50 WEBSTER AVENUE (D3.1) | P&Z 21-060, 22-073, 21-166
Comment Response | September 15, 2022 | US Union Square D3.1 Owner LLC

COMMENT & DISCUSSION POINT SUMMARY

OVERVIEW OF GLARE ANALYSIS

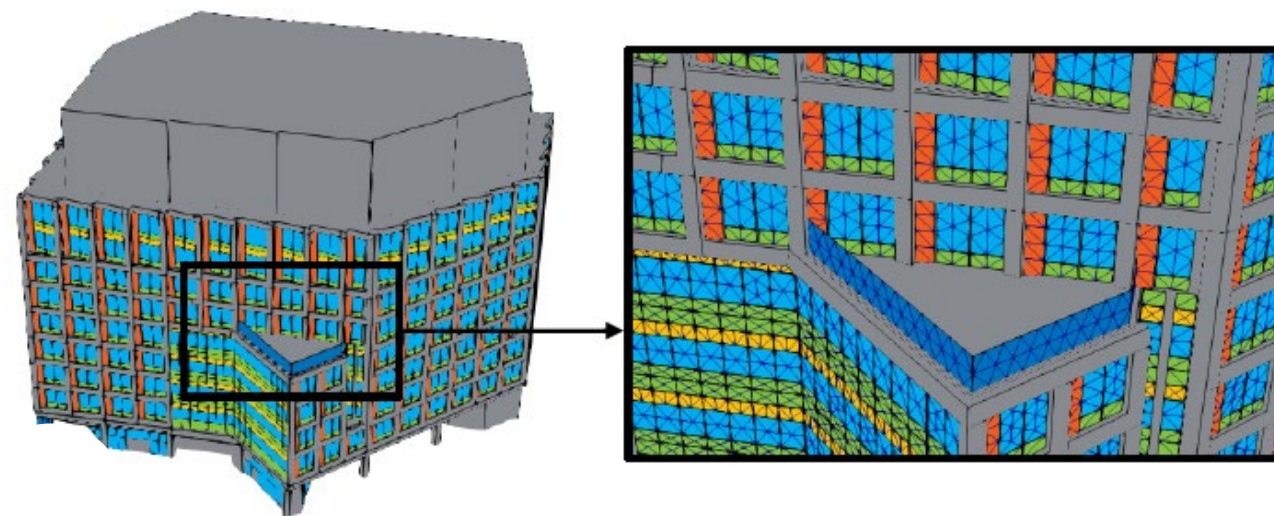
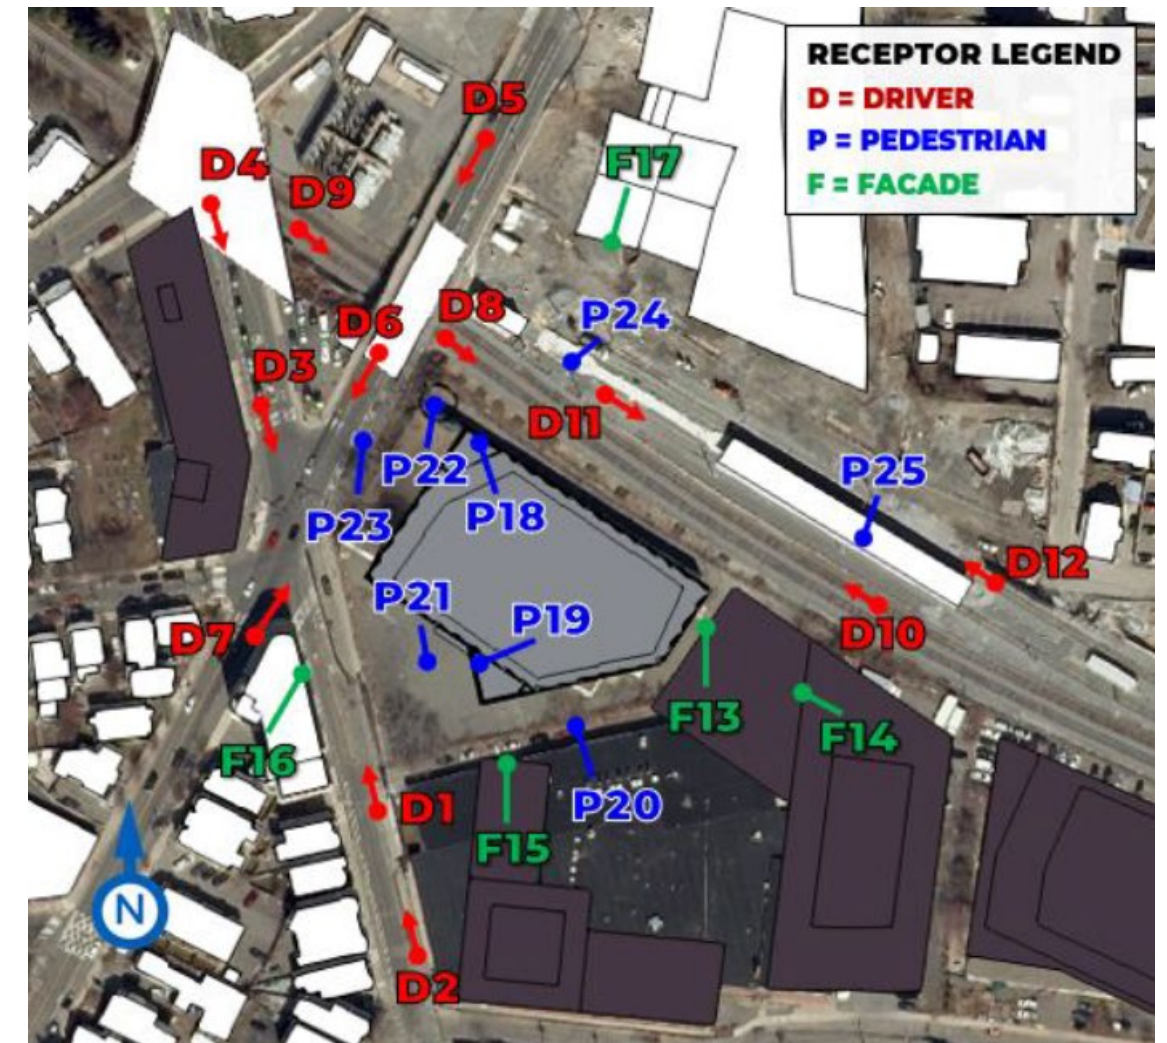
1. Project Wind Analysis
2. Project Glare Analysis
3. Mobility and Accessibility Analysis
 - a. Alley Traffic Patterns
 - b. Interface with Existing Conditions, Signage and Public Access

The Project's solar reflections were investigated to understand the effect of glare on the surrounding environment, assessing potential heat and glare impacts on pedestrians, property and motorists.

- Landscape elements were NOT included in the analysis, and their potential for reduction of solar reflections was ignored.
- The south facing portion of the building, detailed to feature the site's glass history, was included in the analysis. The material specification will meet the requisite standards to ensure it does not impose undue glare.

1. The reflections created by the building are typical for a contemporary building in an urban center.
2. No glare impacts are expected to pose safety risks to pedestrians or property.
3. Glare impacts on drivers occur when the sun would already be in driver's view
4. The pavilion was predicted to have some potential to create reflections but can be mitigated with material selection.
